MEMORANDUM

Re: Modifications to Design Review approval at approximately 2105 East 2100 South: Design Review - PLNPCM2019-01170

Property Address: Approximately 2105 East 2100 South

REQUEST: The project received Design Review approval from the Planning Commission on September 23, 2020. The applicant has requested modifications to the approved design. These changes are required by ordinance to be reviewed by the Planning Commission as only minor modifications can be approved administratively.

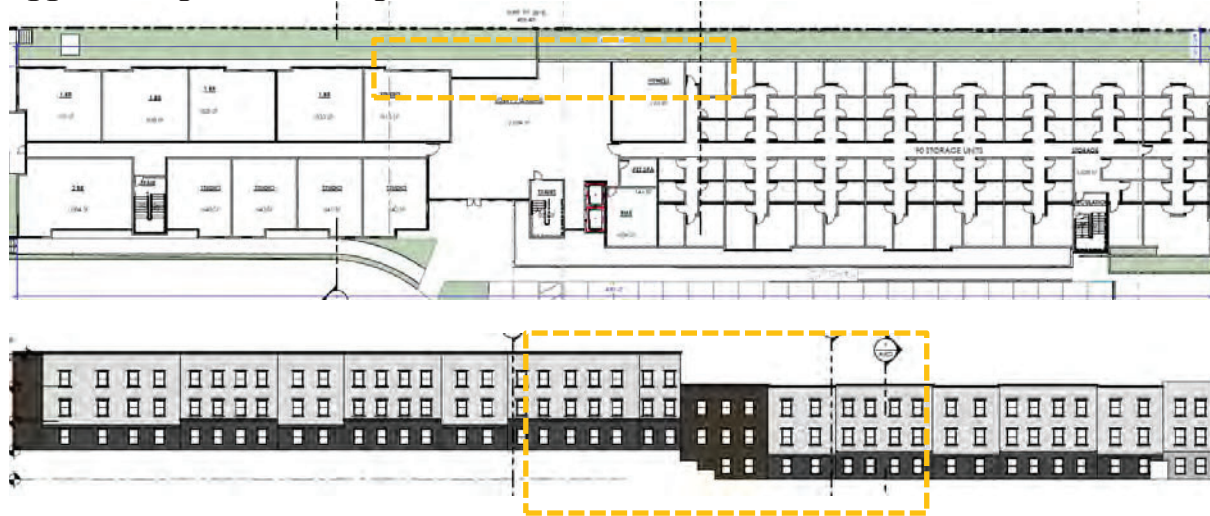
The proposed design is similar in shape, site layout, land use and height to the originally approved design. The modifications are primarily focused on the building articulation, exterior building materials, modifications to window placement and design, the addition of balconies, as well as a

redesign of Building 2 façade to accommodate a change in grade. The overall design changes proposed by the applicant are discussed below. A full list of changes can be found in Attachment A.

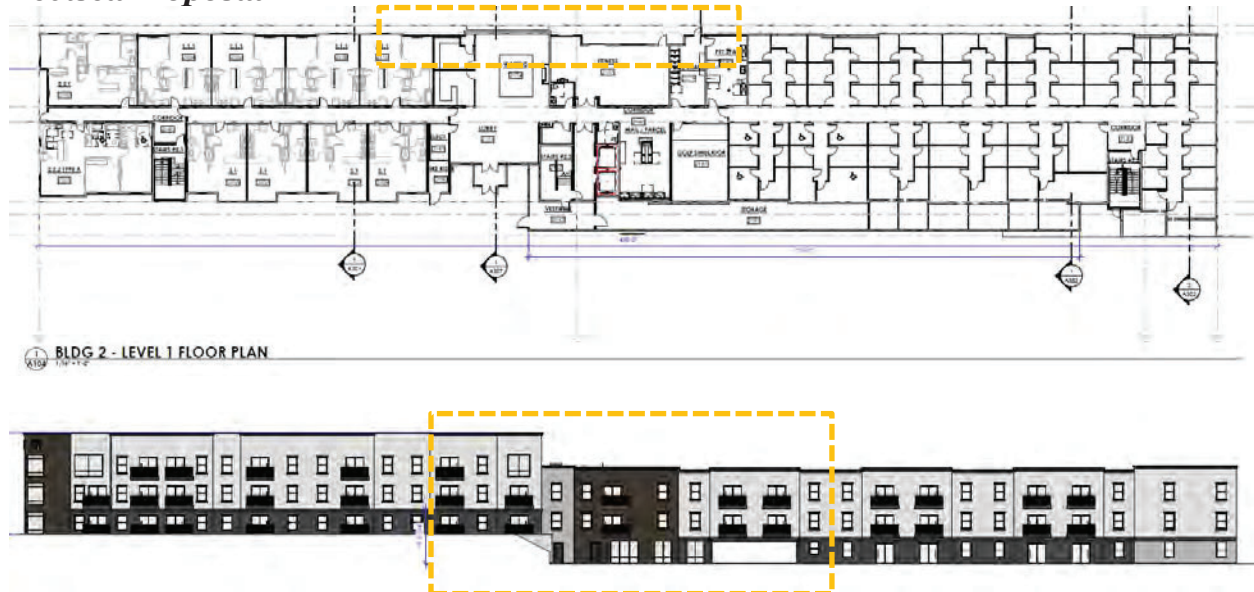
The most notable changes are proposed to Building 2 (the north building) to accommodate a significant step in the finished grade on the north face of the building. The location of this step in grade was shifted to the east to avoid conflict with electrical gear on the adjacent property. This change caused a modification in layout and footprint of the building, but also allowed for the addition of a second exterior outdoor roof space. The area that was shifted to accommodate the grade change, as well changes to the layout, is shown below in orange. Stucco was also added as a new material on the north elevation, as well as balconies.
